STAFF RECOMMENDATION

1906 Bernard Avenue

Application: New construction—infill

Description of Project: Application is to construct a duplex infill.

Figure 1. The vacant lot at 1906 Bernard Avenue.

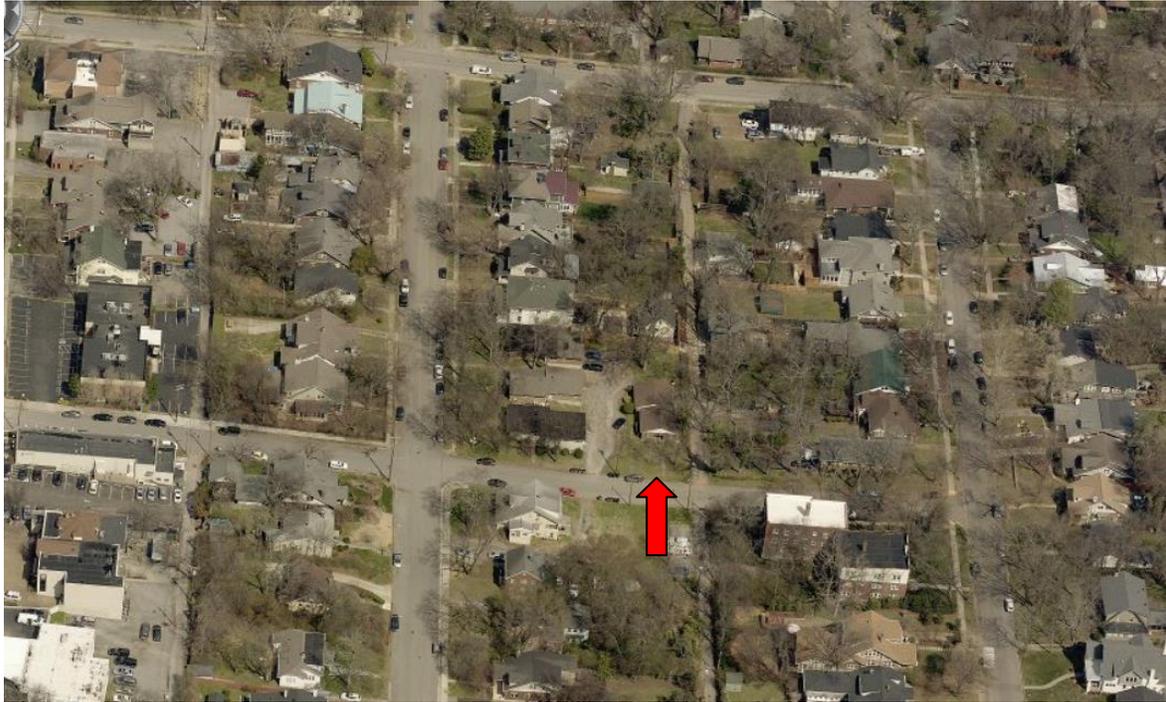
Background: 1906 Bernard Avenue is a vacant lot (Figure 1). MHZC staff issued an administrative permit for the demolition of the non-contributing structure formerly on the lot in October 2016. 1906 Bernard is the only lot that is oriented towards Bernard Avenue; all other lots have side lot lines that face Bernard.

Figure 2 shows the side alley and the cross slope of the lot.

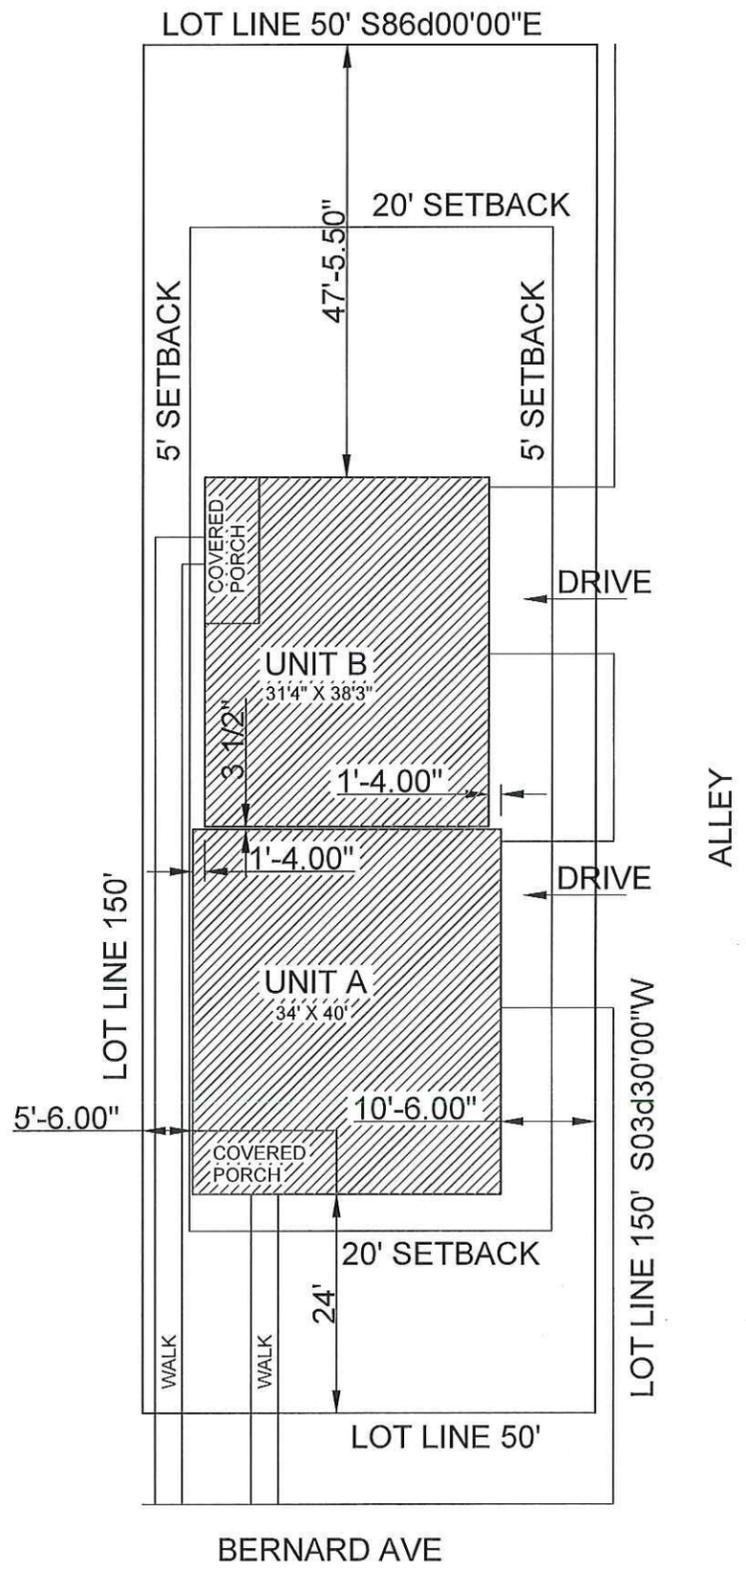
Outbuildings: The design guidelines state that attached garages can be appropriate when they are located at the basement level and are located on the site where outbuildings were historically located. Because of the cross-slope of the lot, basement-level garages are possible on the right/side alley elevation (Figure 2). The two proposed garages on the right/side alley elevations are at basement level, and are pushed back from the front of the house towards the rear, where outbuildings were historically located. They will be accessed via the side alley, which is appropriate since the site lacks a rear alley. Staff finds that the proposed garages meet Section II.B.1.h of the design guidelines.

SITE PLAN
SCALE: 1"=10' (24" X 36" SHEET)
SCALE: 1"=20' (11" X 17" SHEET)

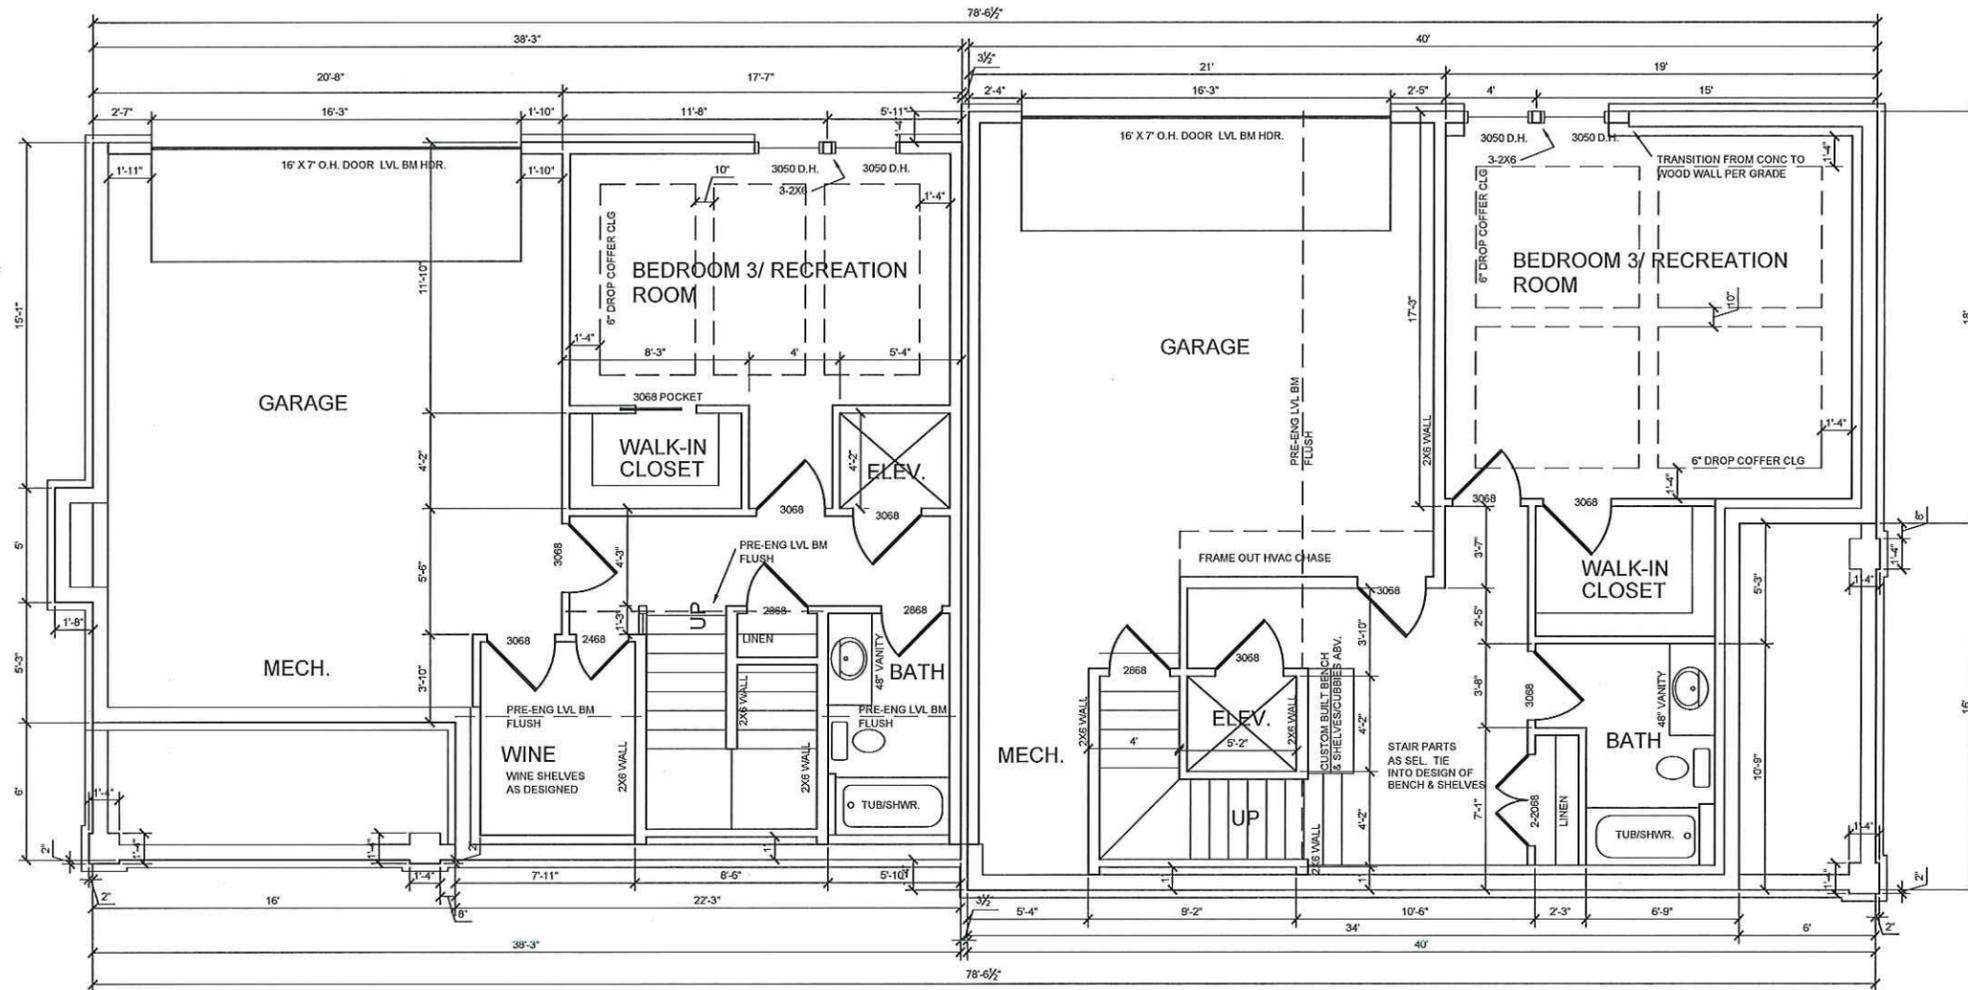
Setback & Rhythm of Spacing: The proposed infill meets all base zoning setbacks. It is five feet, six inches (5'6") from the left side property line and ten feet, six inches (10'6") from the right side property line, which abuts an alley. The infill will be forty-seven feet, five inches (47'5") from the rear property line.

Because there are no other houses that face Bernard Avenue, there is more leeway with the appropriate front setback. The applicant is proposing to situate the infill approximately twenty-four feet (24') from the front property line. This will approximate the front setback of the house previously on the lot. It will also ensure that the infill's front façade will be several feet behind the side facades of the houses next door, which face 19th Avenue South and 20th Avenue South. Staff finds that the proposed front setback is appropriate and that the proposed setbacks meet Section II.B.1.c. of the design guidelines.

FRONT ELEVATION
SCALE: 1/4"=1'-0" (18"X24" SHEET)
SCALE: 1/8"=1'-0" (8.5"X11" SHEET)

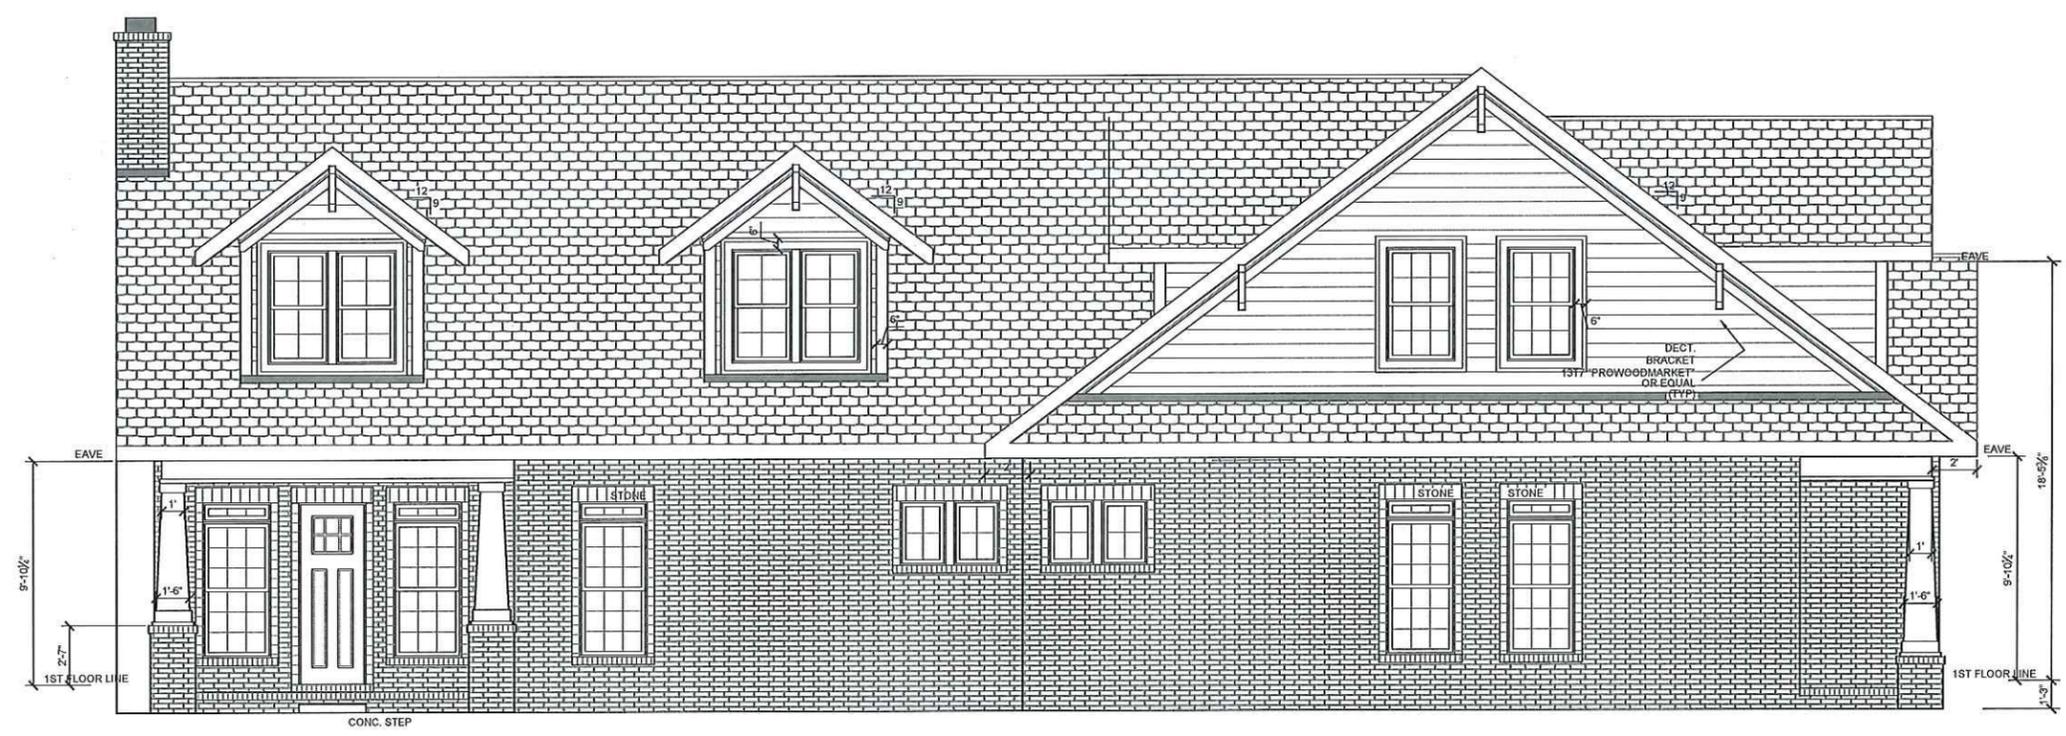
Height & Scale: The proposed infill is one and one-half stories at the front, and because there is a slope to the site, the right/side alley-facing façade is two and two-half stories. At the front, it has a foundation height of one foot, three inches (1'3"), and an eave height of eleven feet (11'). Staff recommends that the foundation height and finished floor height be inspected in the field to ensure that at the front they are compatible with the historic context. At the front, the height of the house is twenty-eight feet (28'), which staff finds meets the historic context. Historic houses in the immediate vicinity are predominantly one-and-a-half stories in height, with heights between twenty-two and thirty feet (22'-30').

* The siding on the drawings measures wider than seven inches (7"). Staff recommends that all siding be smooth face with a maximum reveal of five inches (5") in order to meet the design guidelines.

****The front door is drawn as 1/3 glass, whereas the design guidelines state that front doors should be at least half glass. Staff recommends that the front door be at least half glass.

Roof form: The primary roof form is a side gable with at 9/12 pitch. There is a lower gabled front bay with a 9/12 pitch. The front dormer is gabled with a 9/12 pitch; it is recessed two feet (2') from the main front wall. The dormers on the rear portion of the side facades are also gabled with a 9/12 pitch. They are inset one foot (1') from the wall below, which staff finds to be appropriate because this part of the addition is inset one foot, four inches (1'4") from the front portion of the infill. Staff finds that the proposed roof forms are appropriate and meet Section II.B.1.e. of the design guidelines.

1. Staff verify the construction height of the foundation and floor systems in the field to ensure that the finished floor line of the new construction is compatible with the historic context;
2. All siding be smooth face with a maximum reveal of five inches (5”).
3. The porch floors and steps be either concrete or wood;
4. The front door be at least one-half glass;
5. Staff approve stone and brick samples;
6. Staff approve all windows and doors prior to purchase and installation;
7. Staff approve the roof shingle color;
8. The HVAC units be placed on the rear façades, or on a side façade beyond the midpoint of the house.

LEFT ELEVATION
SCALE: 1/4"=1'-0" (18"X24" SHEET)
SCALE: 1/8"=1'-0" (8.5"X11" SHEET)

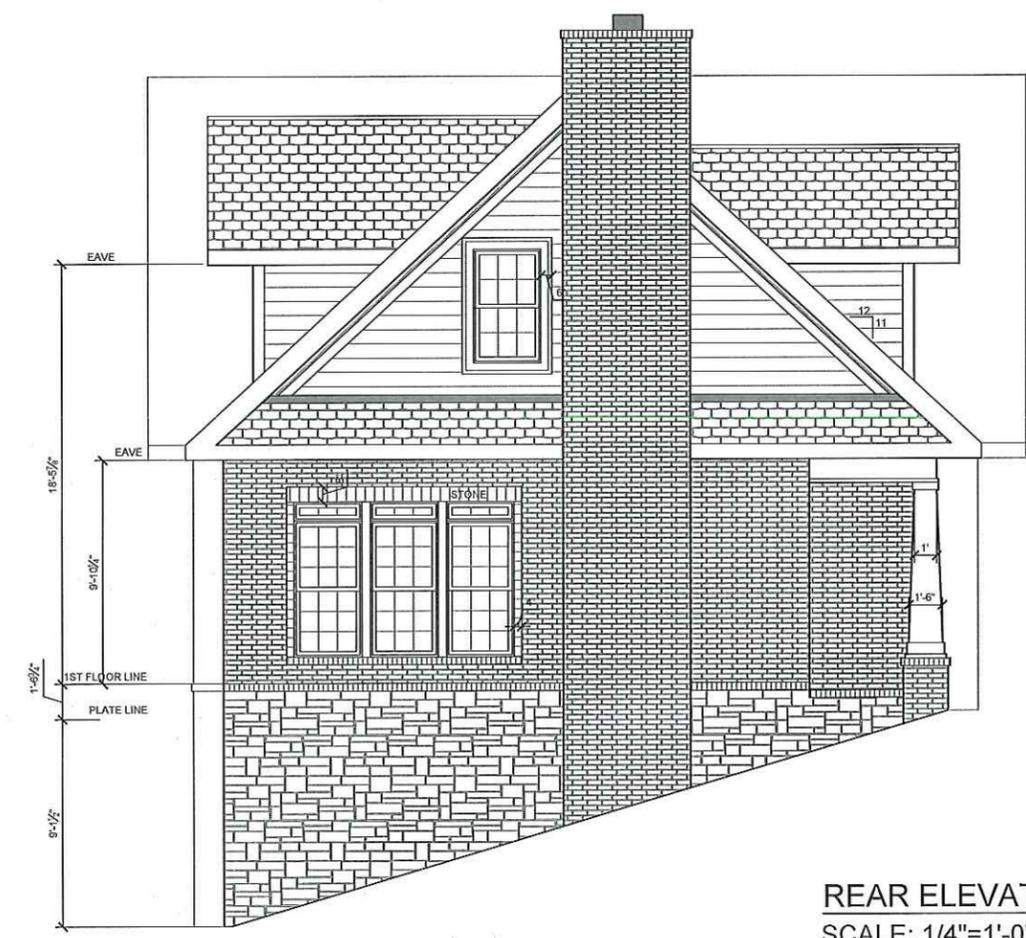
** The wall of the house behind the side porch is stone. This is not typical of historic houses, where changes in material typically happened at the floor level. However, because this façade will not be highly visible, staff finds the stone to be appropriate.

Orientation: The proposed duplex has one primary entrance facing Bernard Avenue, giving the façade the appearance of a single family house. The front entrance has a partial width front porch that is six feet (6') deep. The entrance to the rear unit is on the left side elevation, towards the rear. It also has a porch that is six feet (6'6) deep.

The side porch and entrance is all the way at the rear, and is inset from the front portion of the house, reducing its visibility. It will read as a secondary entrance, which is appropriate. A walkway will be added both to the front porch and around the side of the house to the side porch entry. Vehicular access to the site will be via an alley that runs along the right side of the property. Staff finds that the proposed orientation meets Section II.B.1.f. of the design guidelines.
